2004 - 2009 Cadillac XLR: Service Bulletin: #01-07-30-032E: Transmission Oil Leaking From Transmission Vent

#01-07-30-032E: Transmission Oil Leaking From Transmission Vent (Replace Transmission Case Cover (Channel Plate) Gasket) - (Sep 29, 2008)

Models: 1997-2009 GM
Passenger Cars and
Light Duty Trucks
(including Saturn)

with Hydra-Matic
4T65-E Automatic
Transmission (RPOs
MN3, MN7, M15, M76)

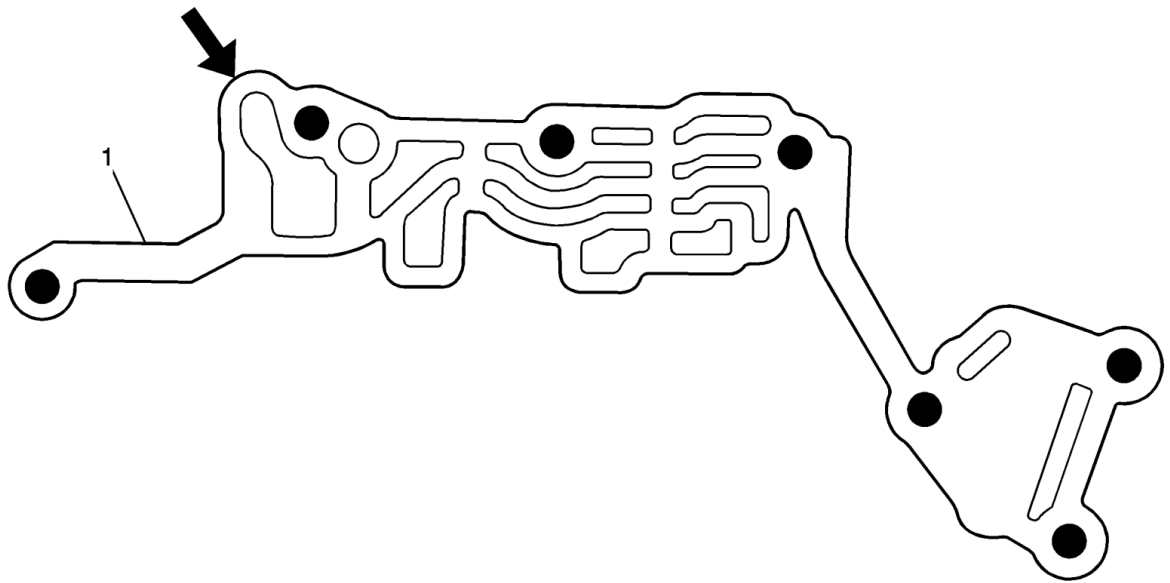
To correct this condition, replace the case cover (channel plate) gaskets (429 and 430). Refer to Unit Repair publication in SI of the appropriate vehicle being serviced.

Visual inspection of the upper gasket (1) will reveal damage at the referenced area.
